SLR-AVM-02

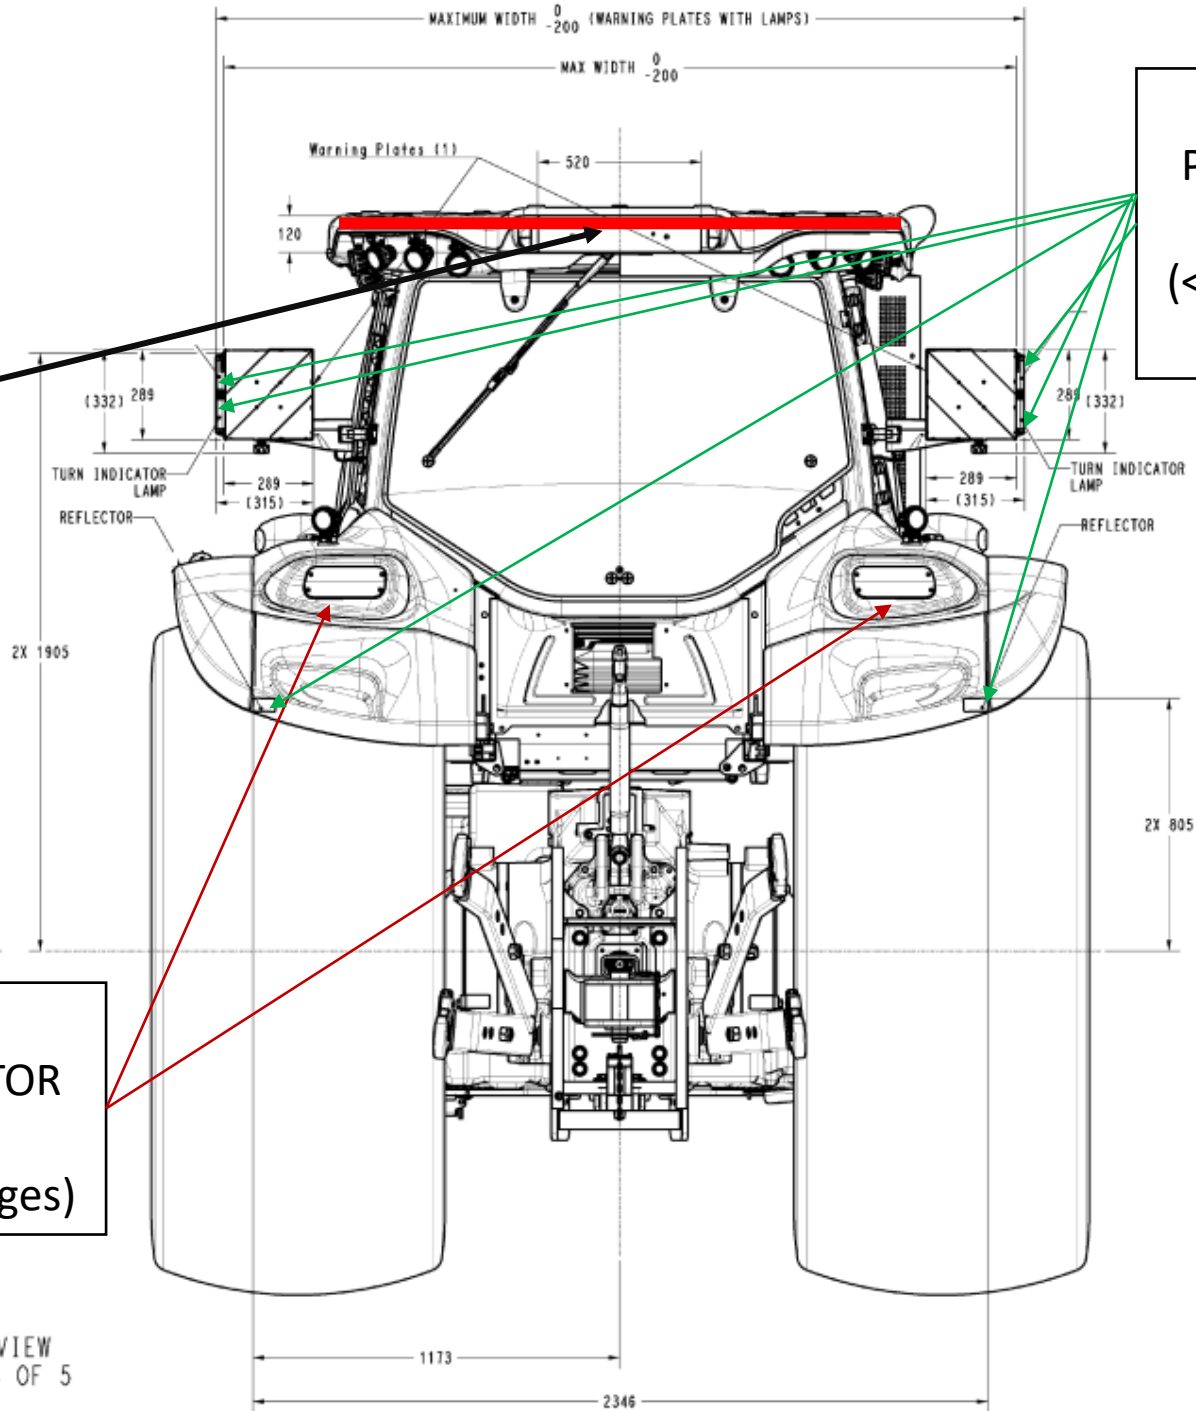
IF, FOR DESIGN AND SAFETY REASONS, WE'D LIKE INTRODUCE ADDITIONAL REAR POSITION LAMPS ON THE TOP OF THE CAB (POSSIBLY A UNIQUE «RED LINE») HOW COULD IT BE DONE (FOR VEHICLES > 2550 MM) IF REAR POSITION LAMP NUMBER IS LIMITED TO 4?

«ADDITIONAL» REAR POSITION/DIRECTION INDICATOR /REAR REFLECTOR DEVICES (< 400 mm respect to outer edges) For tractors width > 2550 mm

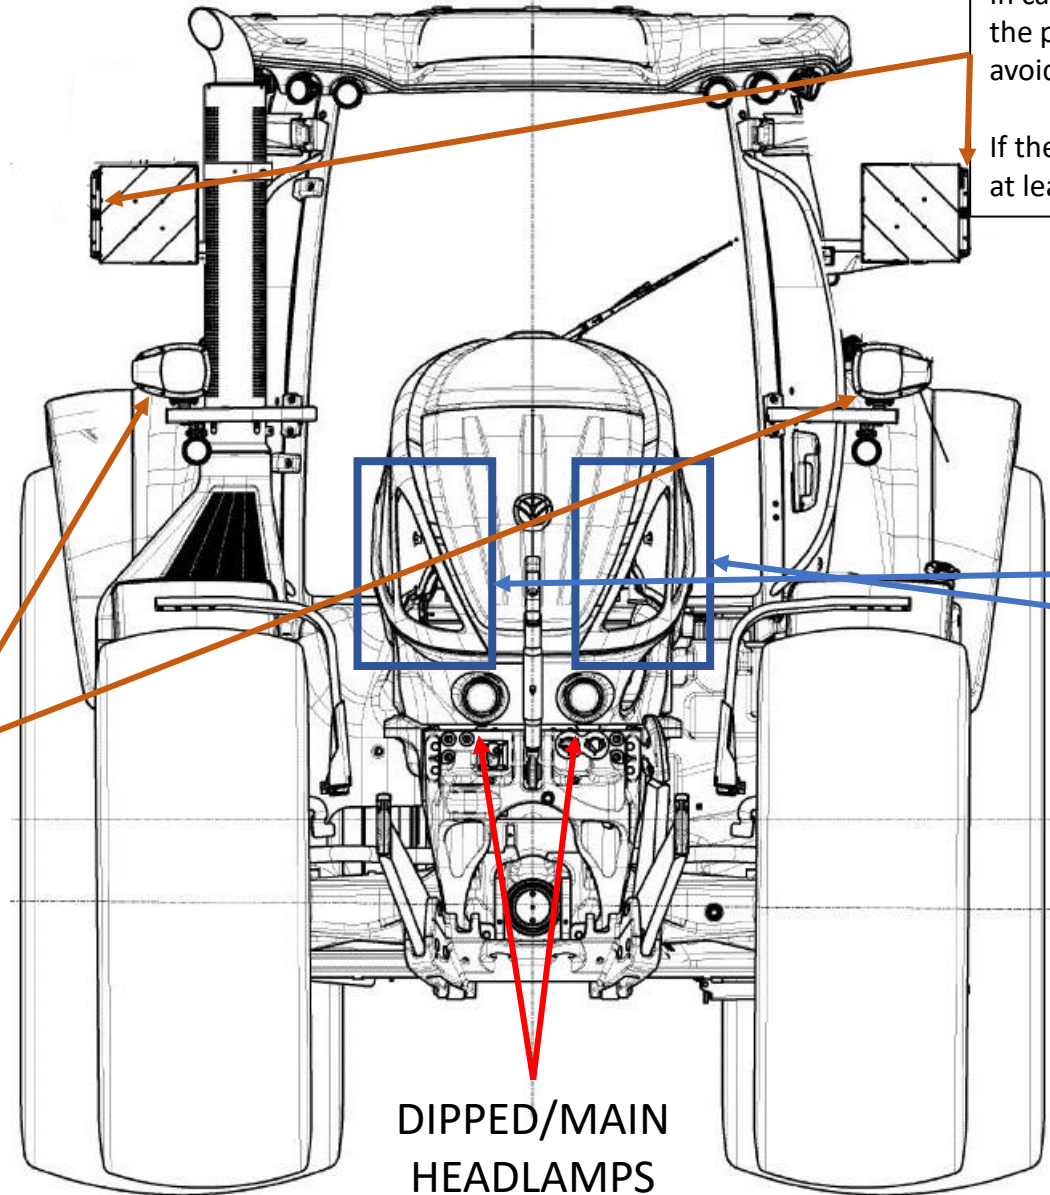
«ORIGINAL» REAR POSITION/DIRECTION INDICATOR /REAR REFLECTOR DEVICES (> 400 mm respect to outer edges)

«ADDITIONAL» FRONT POSITION LAMPS or
END OUTLINE MARKER LAMPS??
In case the tractor is much wider than this configuration,
the presence of «end outline marker lamps» could
avoid to respect the max 400 mm for «original» front position lamps?
If the only way is front position,
at least 6 front position lamp could be needed

«PREFERRED» POSITION
FOR DRL INSTALLATION
(> 400 mm from outer edge)
ALSO IF APPROVED AS FRONT POSITION LAMP
(to keep them ON when dipped beam headlamps are
ON, for design reasons),
NOT POSSIBLE TO INSTALL THEM WITH CURRENT
WORDING (distance between internal edges)

«ORIGINAL» FRONT POSITION LAMPS
(< 400 MM from outer edge
for tractors up to 3000 mm)
